# presents HOW-TO-DO-IT IDEAS from the 999 radio amateurs at GENERAL & ELECTRIC

This G-E HAM NEWS THIRD BOUND VOLUME has been published in answer to many requests for the complete set of issues from January-February, 1956 (Vol. 11, No. 1); to November-December, 1960 (Vol. 15, No. 6). Also, much additional information has been compiled about most of the original articles and combined into a 72-page supplement at the rear of this volume.

FIG. 4 CLOSE-UP VIEW SHOWING THE VERTICALLY-POSITIONED 0,001-MFD. SECOND RF AMPLIFIER GRID BY-PASS CAPACITOR SHIELDING THE PLATE CIRCUIT IN THIS STAGE FROM THE SMALL-DIAMETER CATHODE COIL, L<sub>3</sub>. NEAR THE CENTER OF THE PICTURE.

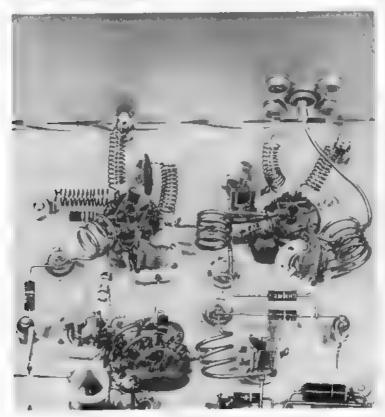
- 4. Newer crystals for the 3rd and 5th overtones make possible a simplified oscillator circuit. Use one section of the 12AT7 as the oscillator in the circuit the crystal manufacturer recommends, and the other section as a doubler (for 60 to 70-Mc. range crystals), or a tripler (for 40 to 46-Mc. range crystals).

DIAGRAM SHOWING CIRCUIT CHANGES TO ADD CENTERING CONTROLS TO THE HAMSCOPE.

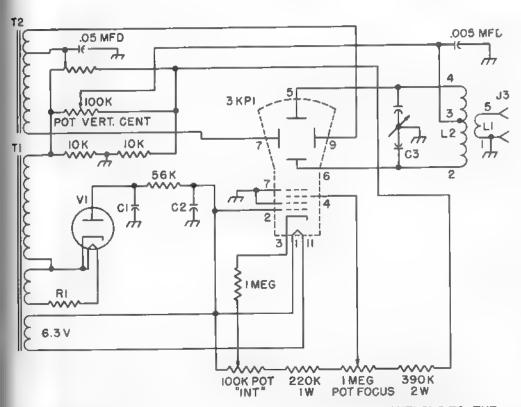
- 10. A number of readers have inquired about converting the war surplus BC-929 oscilloscope to the HAMSCOPE circuit. An article has been published in QST magazine for August, 1957, page 32, describing the conversion of this oscilloscope to a modulation monitor similar to the HAMSCOPE, but with more elaborate circuits.
- 11. Since the side view photo, Fig. 3, and layout drawings Fig. 5 and Fig. 6 in the original issue are pinched in the binding of the bound volume, these illustrations are repeated here.

FIG. 1. SCHEMATIC DIAGRAM FOR A THREE STAGE VERSION OF THE SINGLE BAND TRANSMITTER COVERING BOTH 14 AND 21 MEGACYCLES.

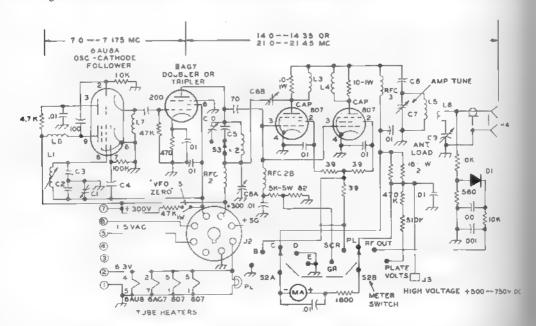
A three-stage version of the single bander transmitter has been tested on the 21 and 28-megacycle bands. In it, an extra dual-purpose tube (6AU8 pentode-triode) has been added as a combined high-C oscillator--cathode follower isolating stage. The 6AG7 tube then operates as a frequency doubler to drive the final amplifier. A block diagram of this tube lineup is shown in Fig. 1 below. Better frequency stability under keying and plate modulation has resulted, as compared to the original two-stage lineup. However, the 3.5 and 7-megacycle models of the two-stage rightage excellent frequency stability under modulation.

This three-stage circuit also can be adapted to the lower frequency bands, by including the component values shown in the tabulation on page 3 of the January-February, 1958 issue; and, the additional information on components given on the preceding pages of the supplemental information for this transmitter. Coils  $L_7$  and  $L_8$  in the oscillator circuit are 0.5 mh. RF chokes.

FIG. 2. CHASSIS LAYOUT DIAGRAM OF A UNITIZED TRANSMITTER RF UNIT, MODULATOR AND POWER SUPPLY WITH THE BASIC SINGLE BAND TRANSMITTER DESIGN.

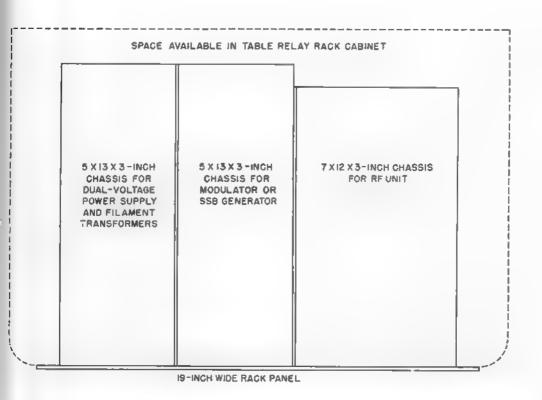
A different mechanical layout for these transmitters has been devised and checked with recently-constructed models. The drawing of Fig. 2 shows the sizes and positions of three chassis which form a complete transmitter: a  $7 \times 12 \times 3$ -inch chassis at the right, with the 7-inch side toward the panel, a  $5 \times 13 \times 3$ -inch chassis, with the 5-inch side toward the panel, for a plate modulator, or SSB generator unit; and another  $5 \times 13 \times 3$ -inch chassis for a dual-voltage power supply unit.

The RF chassis running with the long dimension from front to back makes possible incorporation of a bandswitch to change the single band transmitter design into a multi-band transmitter. An experimental model of a bandswitching transmitter has been constructed and is pictured on the following pages. This model covers the 1.8, 3.5 to 4.0 and 7.0 to 7.3 megacycle bands. Note that the bandswitch flat shaft runs back through the chassis to switch the oscillator and multiplier, driver stages. Then, it turns a pair of miter gears to transmit the bandswitch motion up through the chassis to the switch wafer which changes coils in the amplifier plate circuit. This transmitter is still being tested. More advanced models will be constructed from the information gained from this preliminary model, and published in G-E HAM NEWS during 1962.

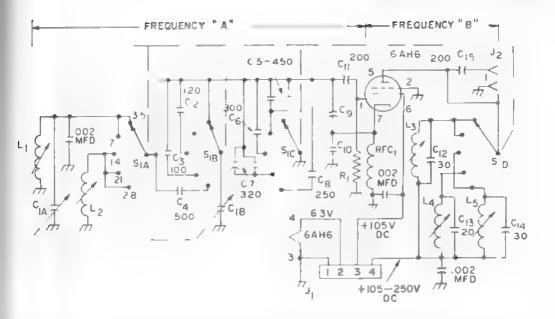
- a.  $C_{13}$  on diagram The last capacitor in the PARTS LIST, shown as  $C_{15}$ , a 20-mmf silvered mica, actually is  $C_{13}$  on the diagram. The " $C_{15}$ " shown with  $C_{11}$  is correct.
- b.  $L_1$  The winding length on National XR-50 coils is 11/16 of an inch long, not 1-1/16 inches long, as specified for the winding length.
- c. R<sub>1</sub> The best value for the grid bias resistor, R<sub>1</sub>, may be determined by experiment, but resistances from 47,000 to 100,000 ohms should be suitable at this point, with the higher value desirable when 200 volts or more is applied to the plate of the 6AH6 tube.
